#### **MEMORANDUM**

**TO:** District of Columbia Zoning Commission

**DATE:** May 10, 2021

**SUBJECT:** Hearing Report for ZC #20-27, Consolidated PUD with related Zoning Map Amendment

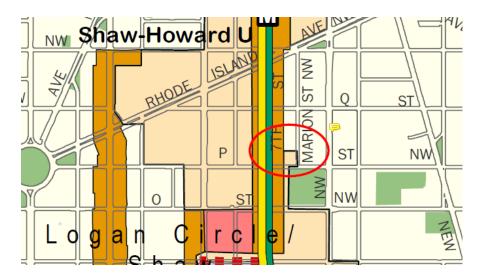
While there may be a potential inconsistency in the proposed density for the small eastern portion of the site that is designated for Moderate Density Residential use, the proposed four story section of the building would qualify as a "low-rise apartment building". Additionally and importantly, the overall project would further other Comprehensive Plan policies that would outweigh any potential inconsistencies with the FLUM designation including most significantly the critical need for new affordable housing units as well as infill development near transit, neighborhood revitalization, and others as detailed in Section VII-B below.

The building would provide a building height and design transition to buffer impacts to the residential row dwellings in the adjoining RF-1 zone to the east along Marion Street. The building height in the massing along Marion Street would be 43'8" and the allowable height in the abutting RF-1 zone is 40 feet by Special Exception. The building height would step up in floors 5-7 to the maximum building height in floors 8 and 9, which would reduce visibility from the east as seen in the sight line diagram in Sheet A15 of Exhibit 28A1.
